## UNITED STATES DEPARTMENT OF THE INTERIOR BUREAU OF LAND MANAGEMENT

5. Lease	Serial No.
SUNDRY NOTICES	AND REPORTS ON WELLS NMSF079	
Do not use this form for abandoned well. Use For	proposals to drill or to re-enter an managem 3160-3 (APD) for such proposals.	n, Allottee or Tribe Name
SUBMIT IN TRIPLICATE -		or CA/Agreement, Name and/or N

## BLOWOUT PREVENTER ARRANGEMENT & PROGRAM

For Drilling to Total Depth & Setting 5-1/2" Production Casing

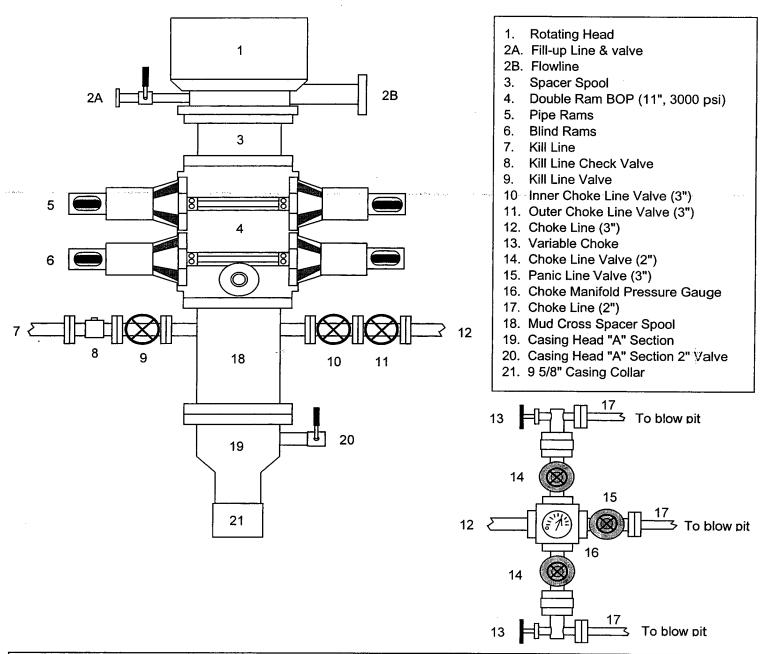
Due to problems with the planned configuration initially submitted	BOP Key Energy was using, ConocoPhillips needs to cha to the following:	nge the BOP
To request an exception to Onshso - Allow us to test our BOP an requirements	ore Order #2 to nd 9-5/8" surface casing to 1000 psi in lieu of Onshor	e Order #2
See attached BOP Schematics - one	e for drilling to total depth & setting 5-1/2" produci	ng casing.

This BOP arrangement is for the drilling operations from the time the 9-5/8" surface casing is set through the setting of the 5.5" production casing. The Casing Head "A" Section will be screwed onto the 9-5/8" surface casing stub. The BOP will be installed on the Casing Head "A" Section. The pipe rams, blind rams, choke manifold, and 9-5/8" surface casing will be tested to a low pressure test of 200 psi to 300 psi and to a high pressure test of 1000 psi (this value is one 44% of the minimum internal yield pressure of the 9-5/8" casing). A 7-7/8" hole will be drilled to toal depth, and 5-1/2" casing will be run and cemented.

In addition to the equipment in the above diagram the following equipment will comprise the BOP system:

- 1. Upper Kelly cock Valve with handle
- 2. Stab-in TIW valve for all drillstrings in use
